3.5 Missile Protection

The information in this section of the reference ABWR DCD, including all subsections, tables, and figures, is incorporated by reference with following departure and supplements.

STP DEP 3.5-1 (Table 3.5-1 and Figure 3.5-2)

Figure 3.5-2 Low-Trajectory Turbine Missile Ejection Zone

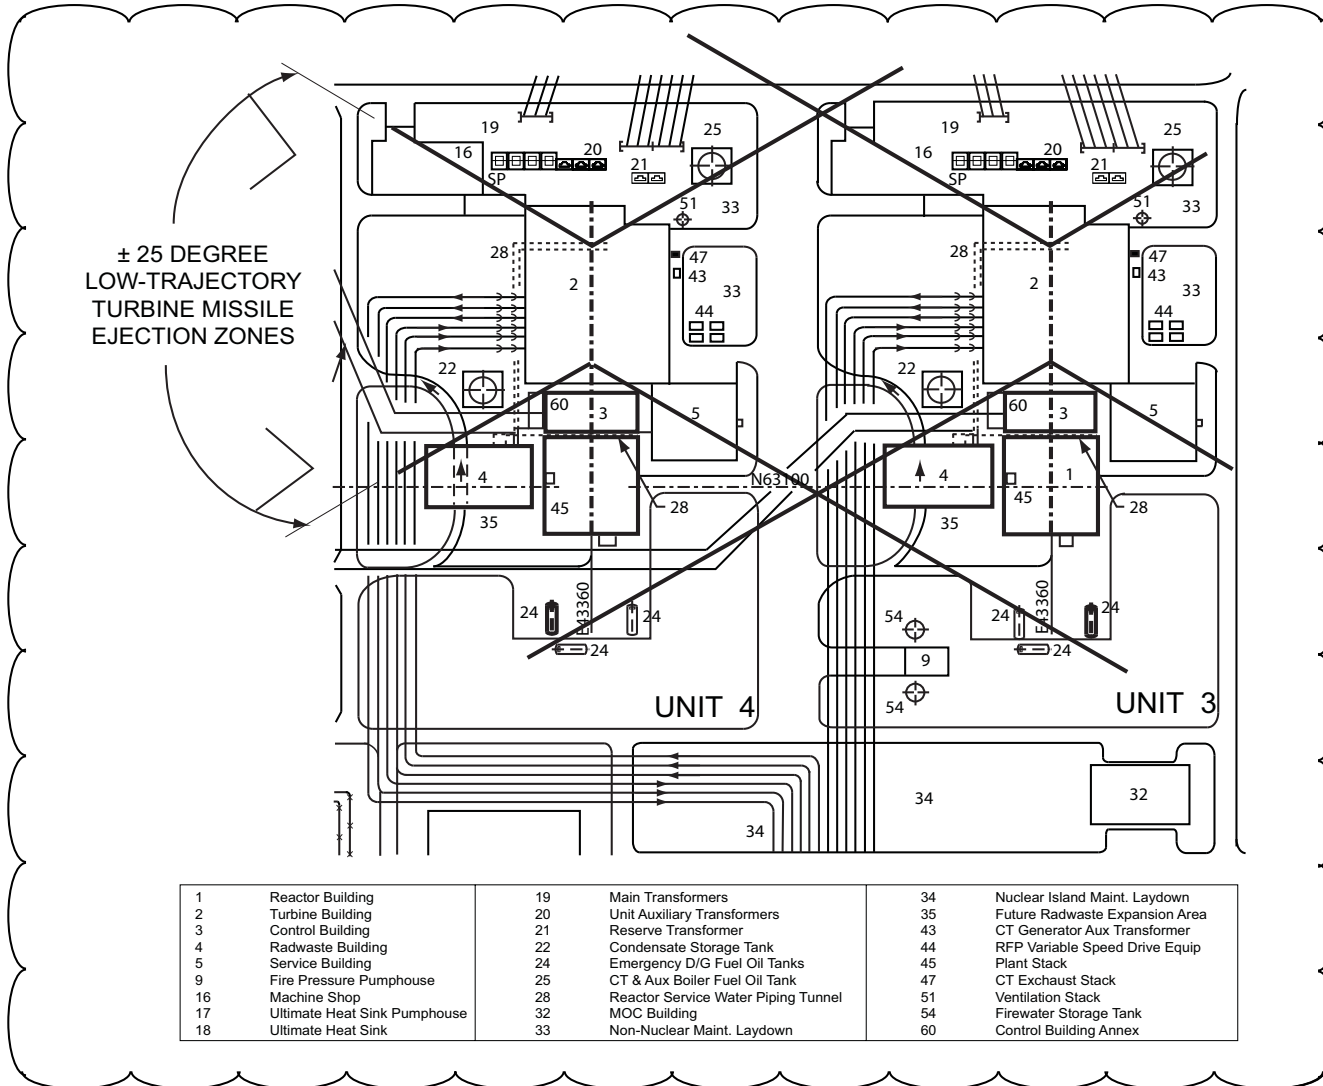
The STP 3 & 4 turbine generator placement and orientation in relation to essential systems of the adjoining unit are illustrated on Figure 3.5-2. Per Regulatory Guide 1.115, the STP 3 & 4 turbine generator placement and orientation is considered unfavorable. Per Acceptance Criteria 1 of Standard Review Plan Section 3.5.1.3 for unfavorable turbine generators, a value of 10^{-2} per year per plant was chosen as a conservative value for the product of strike probability (P_2) and damage probability (P_3). The criteria for unfavorable turbine generator orientation given in Standard Review Plan Table 3.5.1.3-1 and provided in Table 3.5-1 was assumed for the missile generation probability (P_1). The resulting probability of unacceptable damage from a main steam turbine missile (P_4), which is $P_1 \times P_2 \times P_3$, is less than 10^{-7} per year per plant.

Therefore STP 3 & 4 main steam turbine generator placement and orientation meets the acceptance criteria of Standard Review Plan 3.5.1.3 and the guidelines of Regulatory Guide 1.115.
